PRELIMINARY ANALYSIS OF THE “EAST END” PROPOSAL

Neighbors of First Settlement District of Capitol Neighborhoods, Inc., have done the following preliminary analysis of the proposed “East End” infill and redevelopment project with respect to the standards in Madison’s Preservation Ordinance (MGO CH. 41). This preliminary document focuses on two aspects of the Preservation Ordinance:

FIGURE 1. PROPOSED LOT AND ADJACENT LOTS

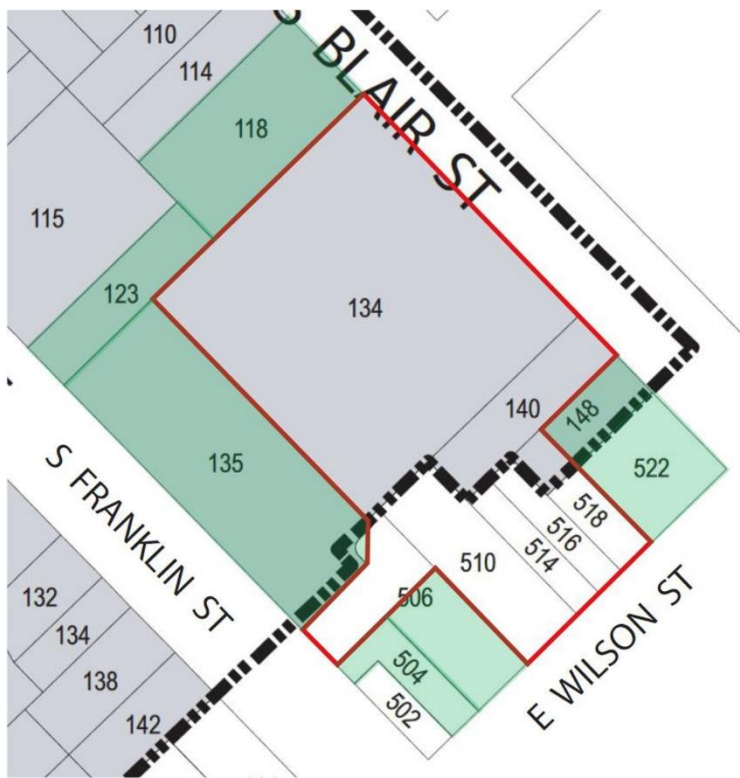
The development team is requesting to combine eight lots, in whole or in part, to form a large lot for their project. The proposed total lot size is approximately 57,081 square feet of which 42,439 square feet of the lot is within the FSD.

Neighbors have created a spreadsheet of lot sizes for this analysis, and we’ve included it for reference (see attachment 1). Our analysis of the adjacent lots (shaded in green in Figure 1) shows that the

FIGURE 2. PROPOSED LOT SIZE COMPARED TO ADJACENT LOTS

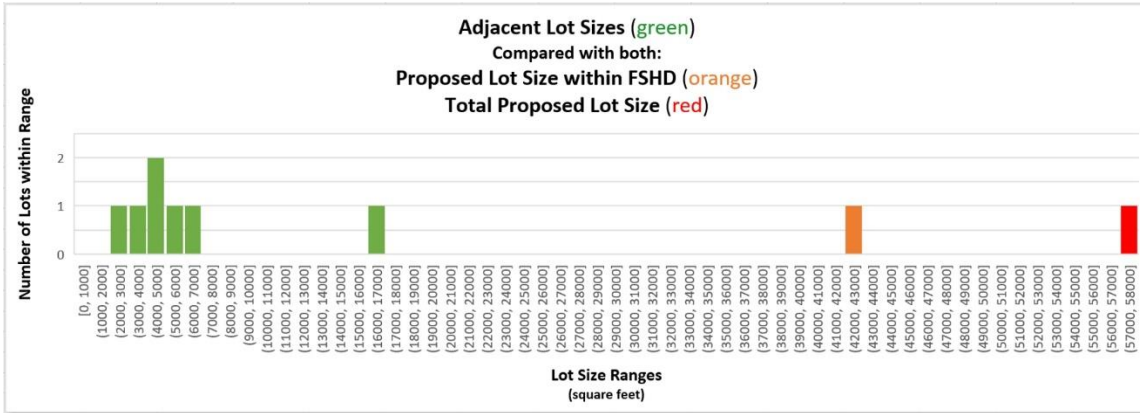
proposed lot will be about **10 times larger** in size than the average size of the adjacent lots. Figure 2 helps further visualize this comparison. It shows the distribution of adjacent lot sizes starting at lots in the range of 0 – 1000

square feet and increasing by 1000 square feet each step. The colored bars indicate the number of lots within a particular size range. The adjacent lots are indicated in green and the proposed lot is in red.

FIGURE 3. PROPOSED LOT SIZE COMPARED TO PATTERN OF LOTS

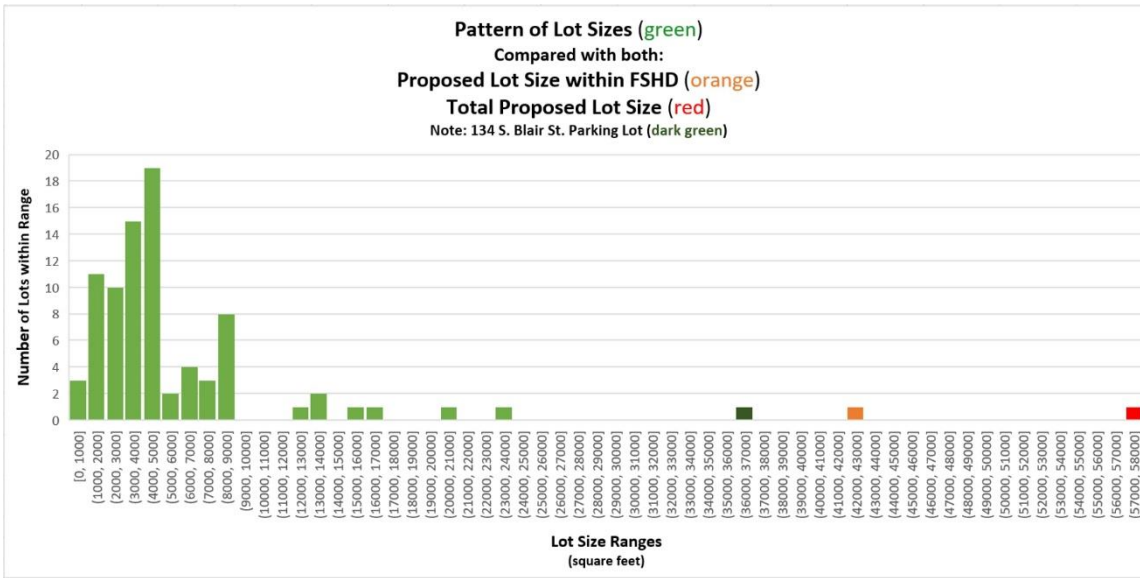
We did a similar analysis for the lots within the FSHD. Our analysis shows that the proposed lot will again be about **10 times larger** than the average size of all lots within our historic. If one only considers lots with pre-1930 construction, to capture the general pattern of lots with historic structures, then that factor grows to nearly **13 times larger**. Again, we’ll use a distribution of lot sizes while now showing all lots within the FSHD in figure 3 below. This distribution is over the same size ranges that grow by 1000 square feet each step as in Figure 2 above. **This underscores that the development team is asking for the creation of a lot that is about 1,000% larger than the average size lot within the FSHD.**

If one only considers the portion of the proposed lot that is within the FSHD (indicated in orange in the figures above) then the factors become 7.7 times larger than the average of all lots and 9.6 times larger than those lots with pre-1930 construction within the FSHD.

Note the dark green (almost black) bar corresponds to the parking lot at 134 S. Blair St., whose underlying lots may need to be resolved and combined as part of the required Certified Survey Map. However, we’ve treated it as a single lot in our analysis since it is listed under a single tax id.

In Figure 3, the smallest lots at the beginning and the larger lots in the middle of the distribution are primarily modern lots that were either divided or aggregated from lots that originally conformed to the pattern of lot sizes within our historic district. Unfortunately, these were created prior to the designation of our historic district and are the kinds of non-conforming lot patterns that MGO 41.18(4) was intended to prevent.

FIGURE 5. SCALE OF STRUCTURE FOOTPRINTS

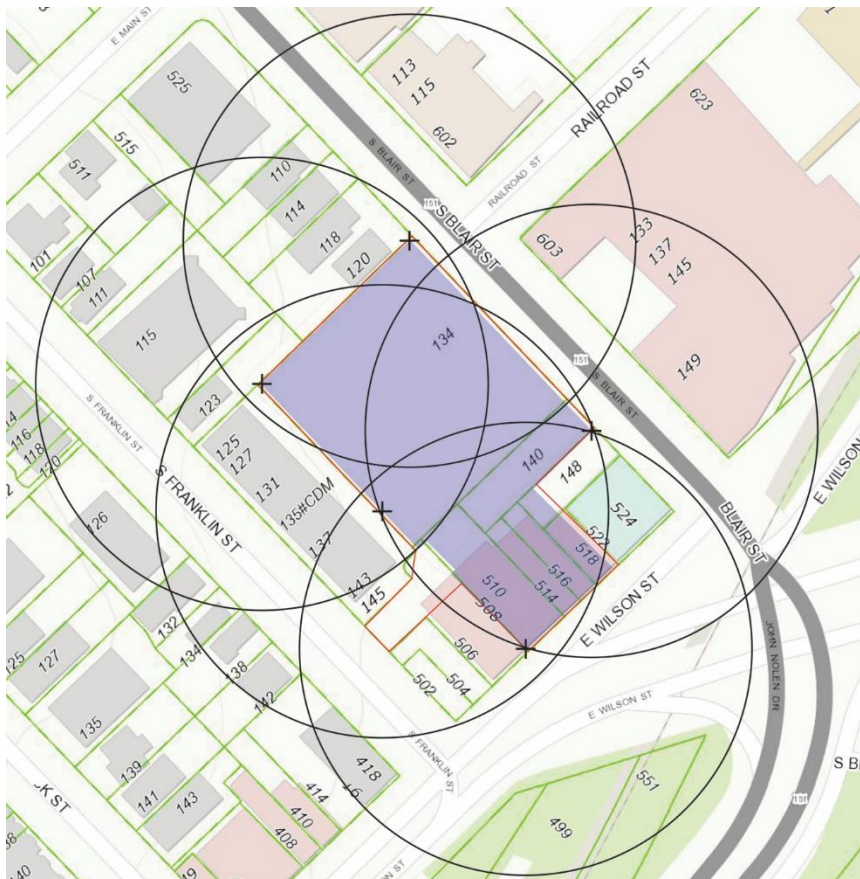
Regarding Scale, Proportion, and Rhythm of Masses and Spaces: When determining the compatibility of a new principle structure’s scale and massing, it is important to consider all other structures within 200 feet, *not just the largest one*. We considered different means for this comparison, including building volumes, and decided that using building footprints was sufficient to get a sense of the relative scale and proportion of the proposed project. Figure 5 shows the proposed structure’s footprint in blue with circles of 200 feet in radius at various points around the structure. Within those circles are footprints of the surrounding buildings (shown in grey for residential uses, and red and green for commercial uses).

FIGURE 6. DEPTH ANALYSIS OF BLAIR ST. BLOCK FACE

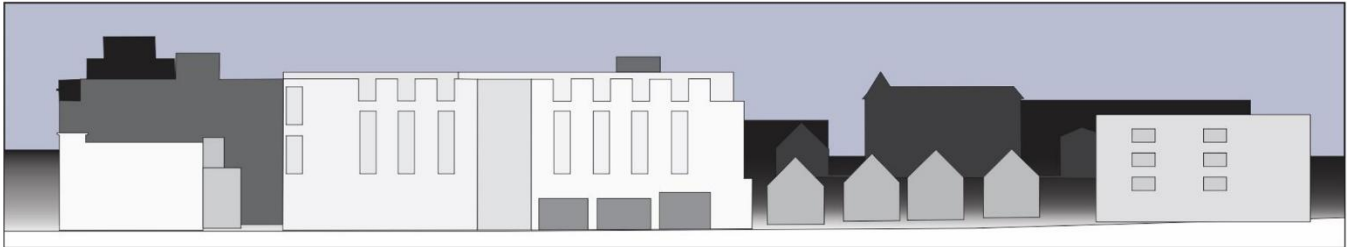
façade. Variations in a structure’s actual height, including setbacks and stepbacks, as well as the spaces between separate structures should also be considered. For this analysis, we’ve again focus on the S. Blair St. elevation since it is within the FSHD. Figure 6. below uses shades of gray to illustrate the approximate depth of structures and their major components from the sidewalk. White indicates a structure is at the sidewalk along S. Blair St. The farther from that sidewalk the darker the gray becomes.

On the left, the 3-story historic Hotel Ruby Marie is in white because it’s at the sidewalk. On the right is the modern 4-story Settlement Place Apartments, which is 9 feet from the sidewalk and so it’s shaded a light gray. In the middle-right are the fronts of the 2½-story period homes, which are farthest from the sidewalk at about 20 feet, so they’re the darkest gray of the structures fronting S. Blair St. The right side of the facade of the proposed structure is essentially at the sidewalk and so it is white. It has deeper bays going back about 40 feet for vehicle access. The left side of the proposed structure’s facade is about 3 feet from the sidewalk. These two faces are separated by a section that is about 10 feet from the sidewalk. The smaller rectangles on the modern apartment and proposed buildings indicate the depth is due to balconies. The black and darker gray shapes are structures facing S. Franklin St. except for the darker gray shape on the left, which is the component of the proposed structure facing E. Wilson St.
